River District Design Commission

NOVEMBER 14, 2019

AGENDA

MEETING OF NOVEMBER 14, 2019

SHEET C5 01
 17 (35,000 SF ±)

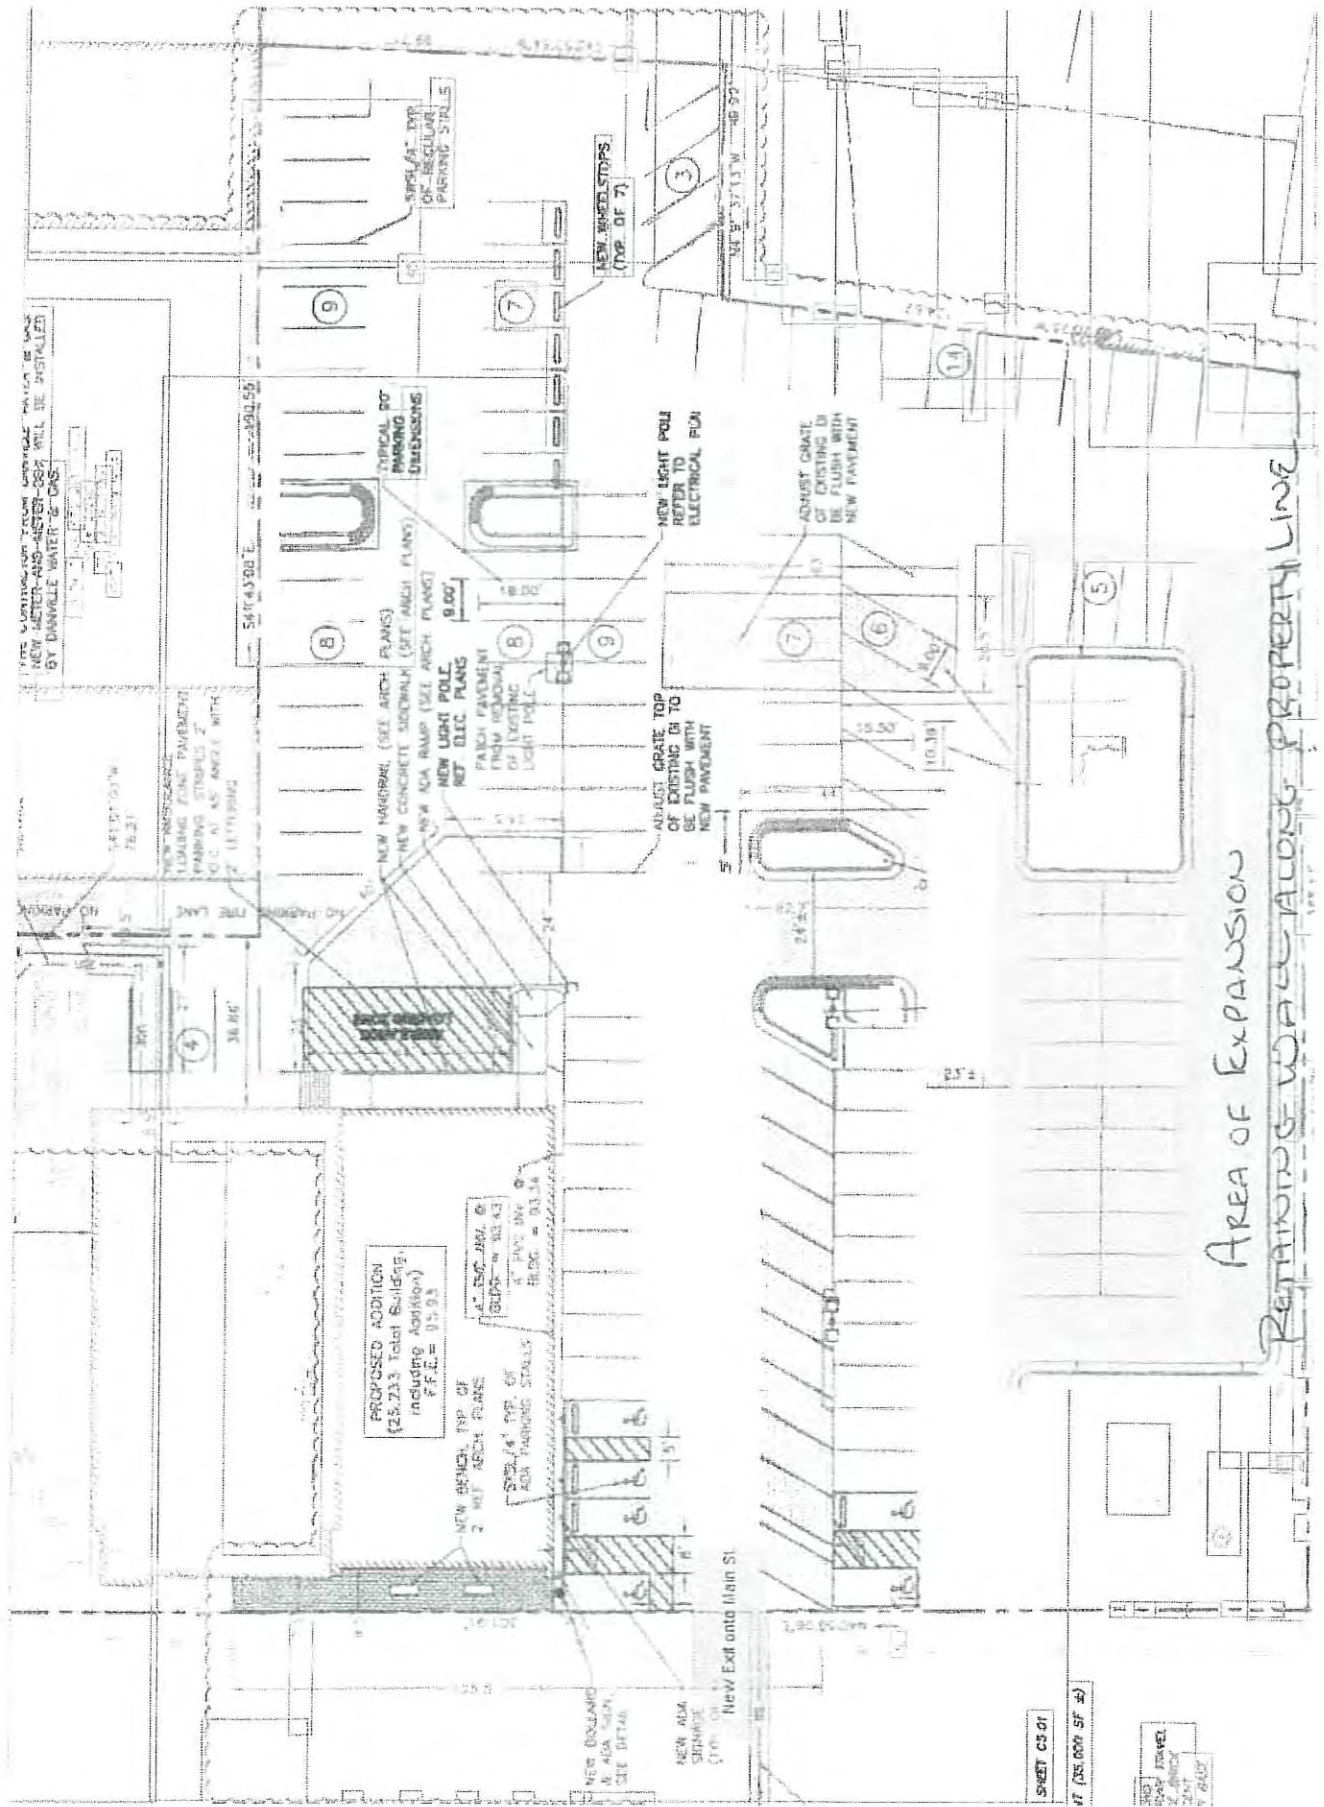
This request was heard in July, but tabled as plans were still being prepared. The proposal now being considered does not require the installation of a retaining wall, nor second access point onto Main Street. This second access point would have required the relocation of a River District sign.

Staff believes that the parking expansion is in keeping with the guidelines as the existing parking lot is asphalt, and this new construction will match.

Mrs. Nicholas stated there also concerns about the traffic flow the two egresses facing Main.

Mr. Johnson stated they are very close together and close to intersection as well.

SHEET NAME
EXISTING AND PROPOSED PLANS AND ELEVATIONS

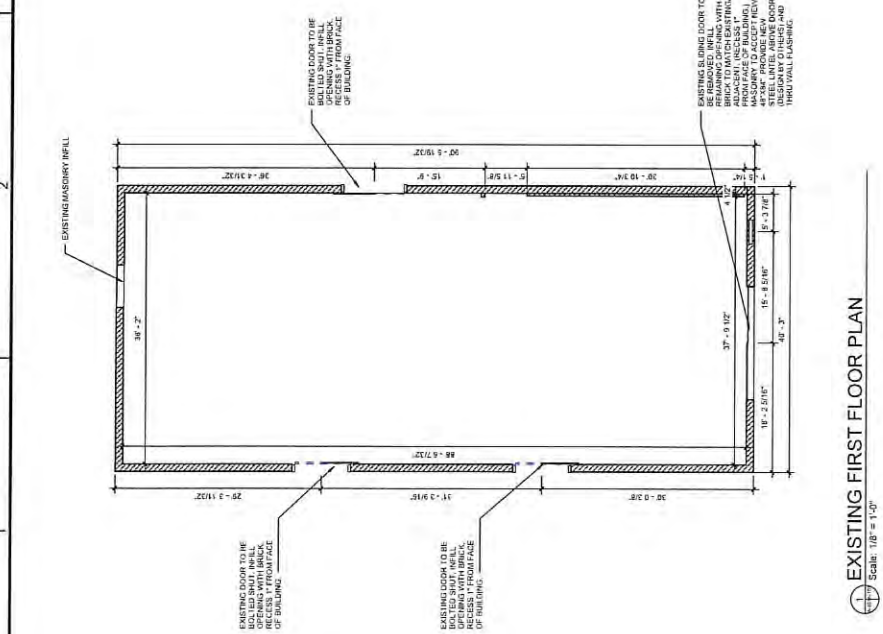
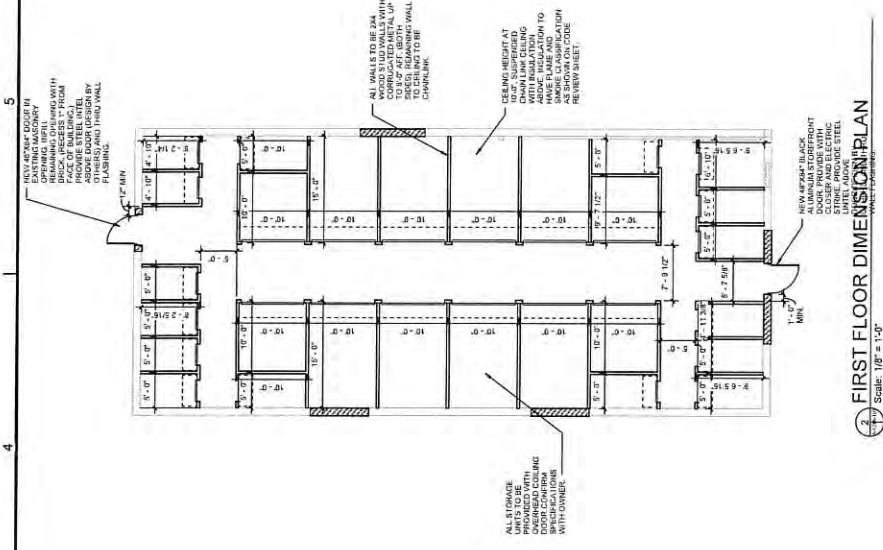
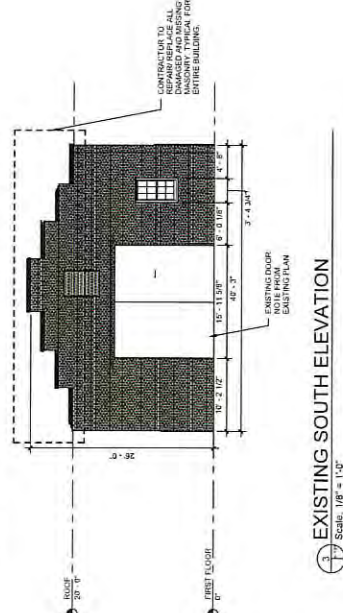
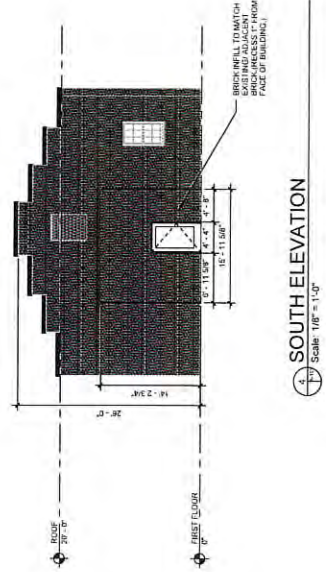
The guidelines do not support the installation of metal (aluminum) doors, nor the changing of door or window openings. This request is to remove the large wooden sliding door, brick the opening and install a black aluminum storefront doorway. Staff understands the concerns for security in this facility, as it has proposed to be a mini-storage unit. This wooden façade could be recreated to provide security without the need to brick the entrance. If the Commission believes that the bricking of the previous doorway is acceptable, then staff believes that at a minimum, the aluminum door should not be approved and a new entry door be wood.

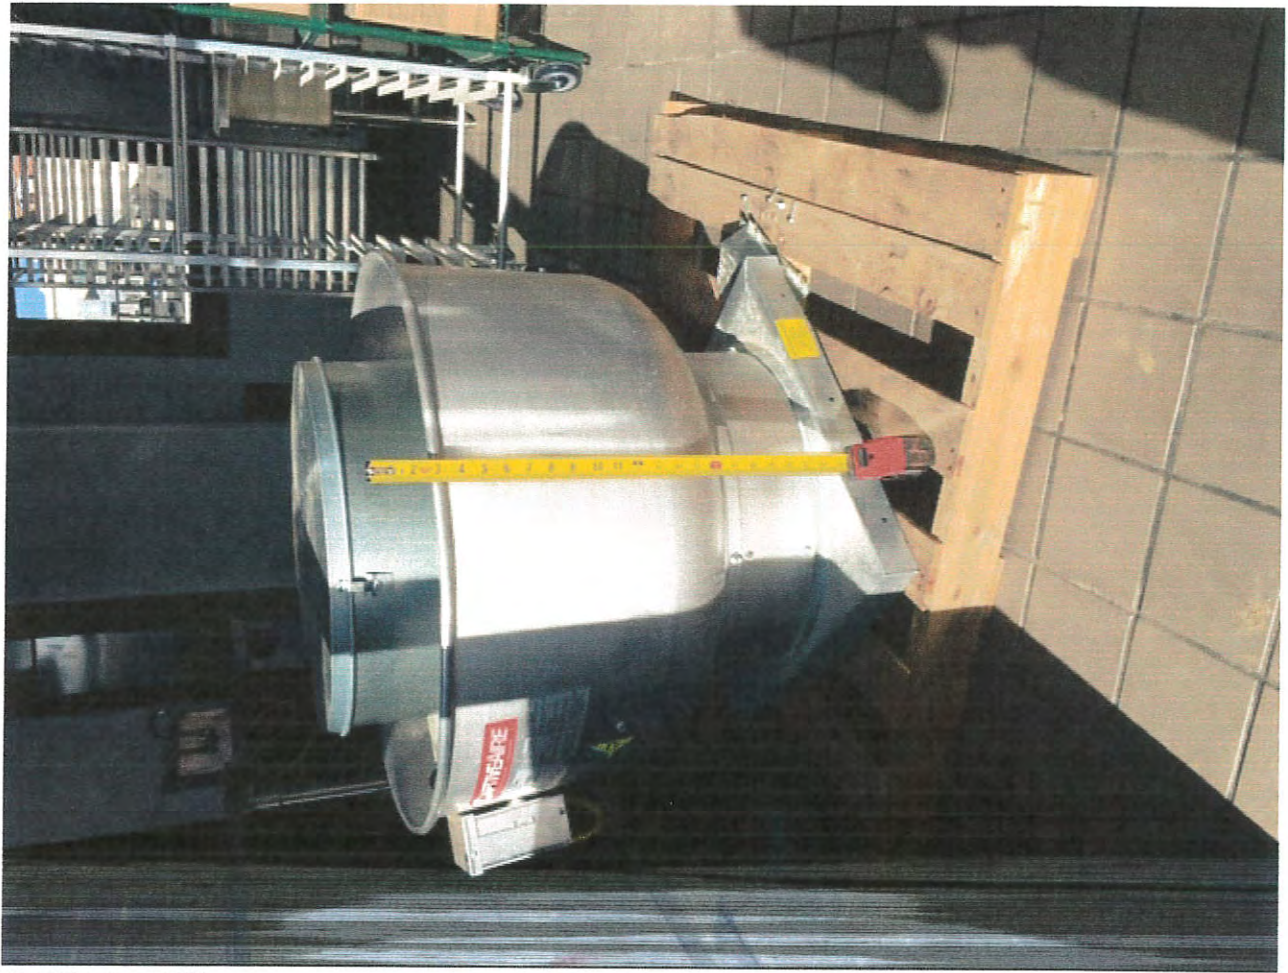
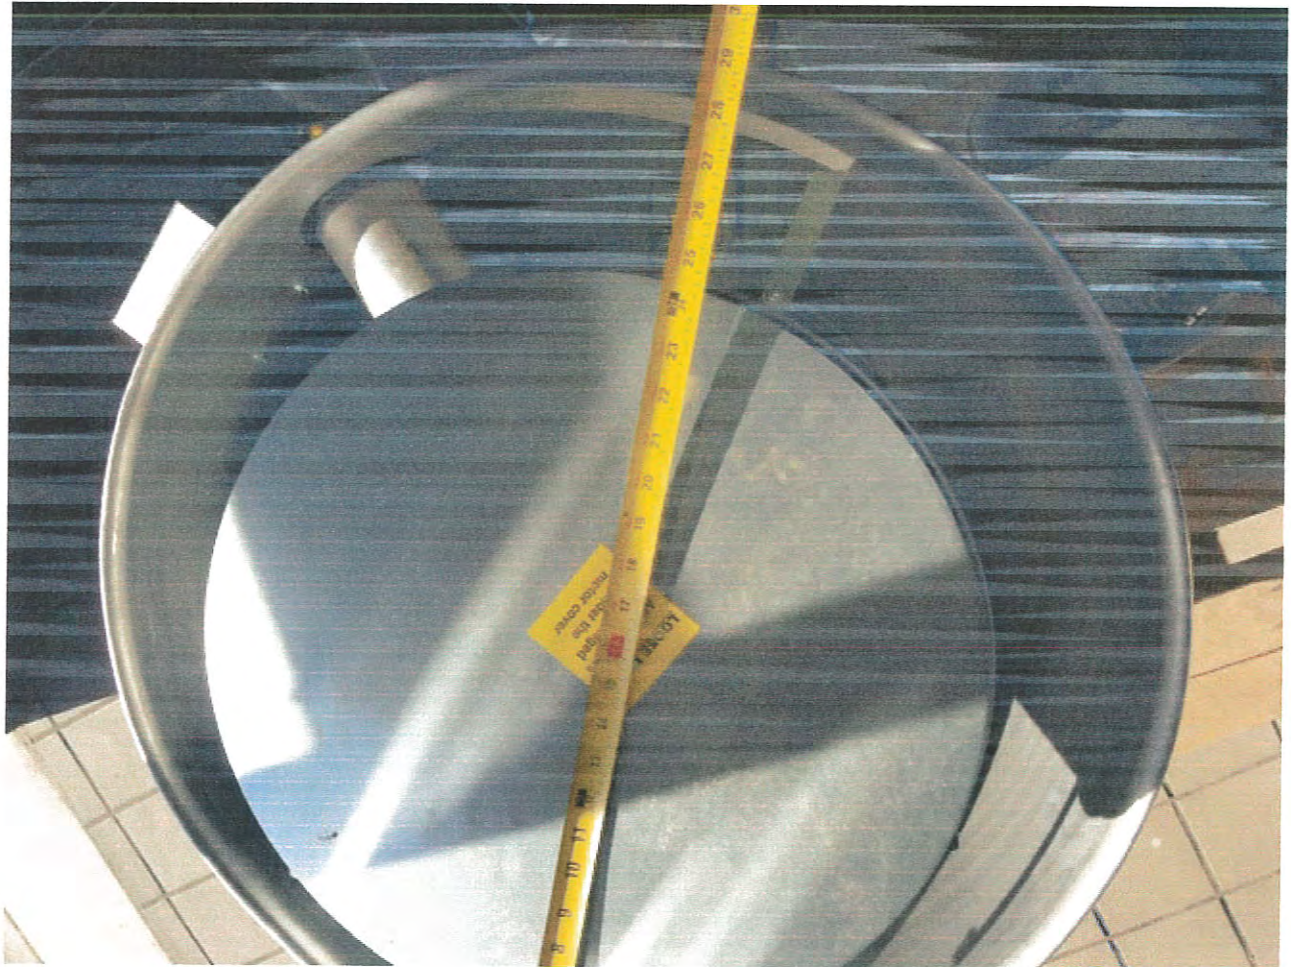
The applicant has come before the Commission on multiple occasions for this project, including installation of the smoker and screening. The applicant did not include the required exhaust system for the smoker so it was not included in the previous review. It has been installed without RDDC approval.

This equipment is not screened from public view. It penetrates the roof of the structure to the east. The aluminum vacuum system could have been modified to not penetrate the roof and exhausted to the rear so to not be so visible (ala ME's Burger's). The smokestack would be a more difficult fix.
